To State Commission on Water Resources Re: Item B.1. SDWP.5951.6 permit to remove Kapala'alaea dam

April 14, 2023

PILALE/ HALEHAKU BAY, HAMAKUALOA, MAUI

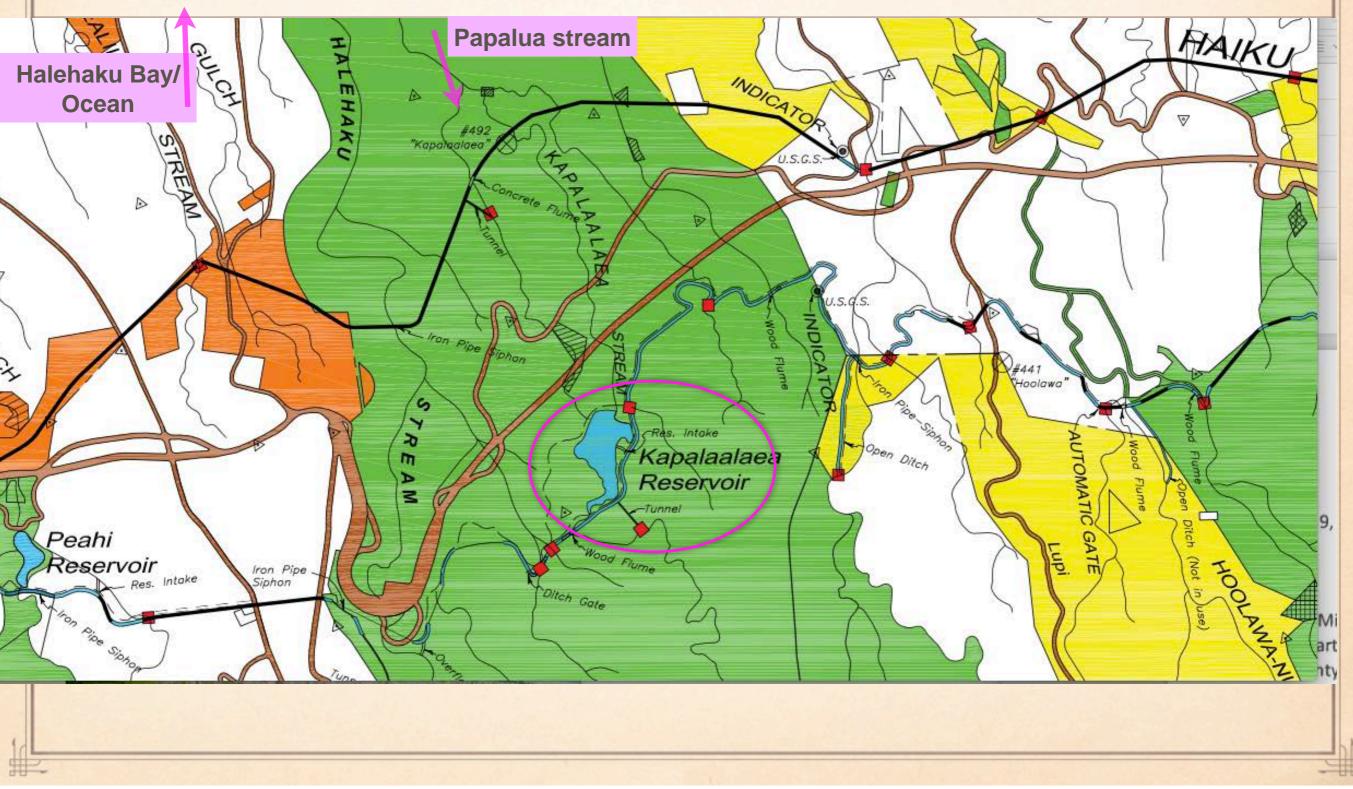
The entire area, along both major stream branches is a rich traditional kanaka archaeological complex. Here are a few views, along the stream trails.....

The extent of this archaeological complex makai of the dam should be mapped and recorded, before floodwater patterns are altered

Papala'alaea Dam closure must act to minimize RISKS observed on nearby streams

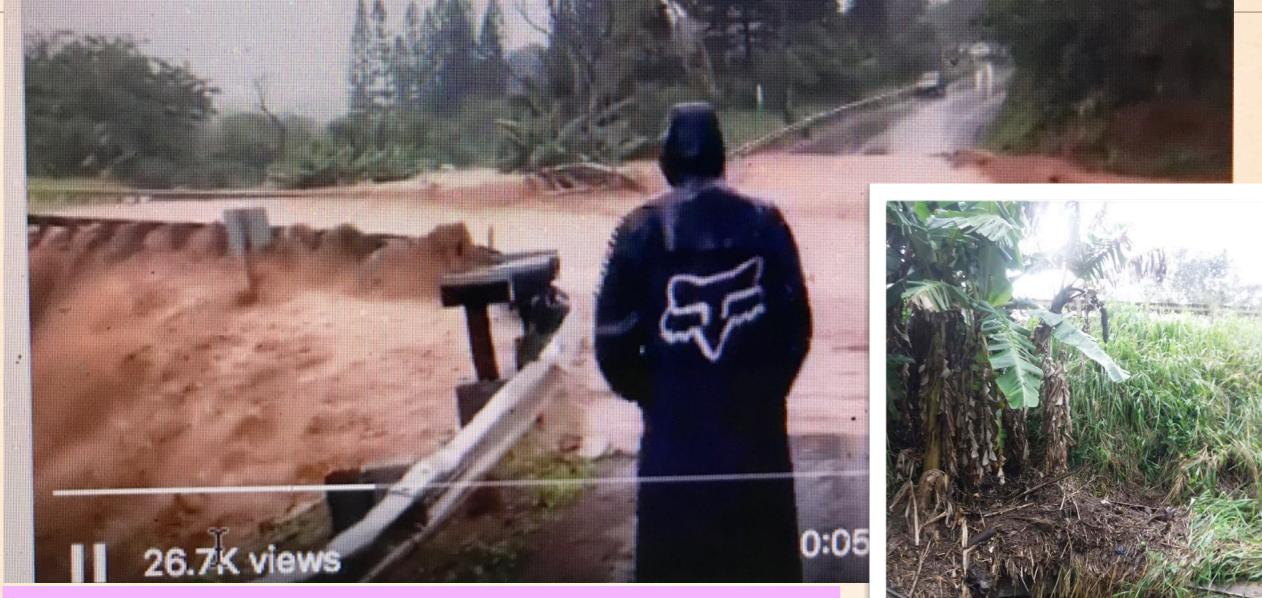
RISKS: An undersized culvert under Hana Hwy in Haiku caused both earth and stone structures to be swept away by floods along East Kuiaha stream, in March 2021

undersized stream culverts under Hana Hwy in in the Kapala'alaea dam area can also be completely overwhelmed by the intense storms we now experience. We need to properly record any traditional sites along the stream bed as part of dam closure, in case they are damaged.
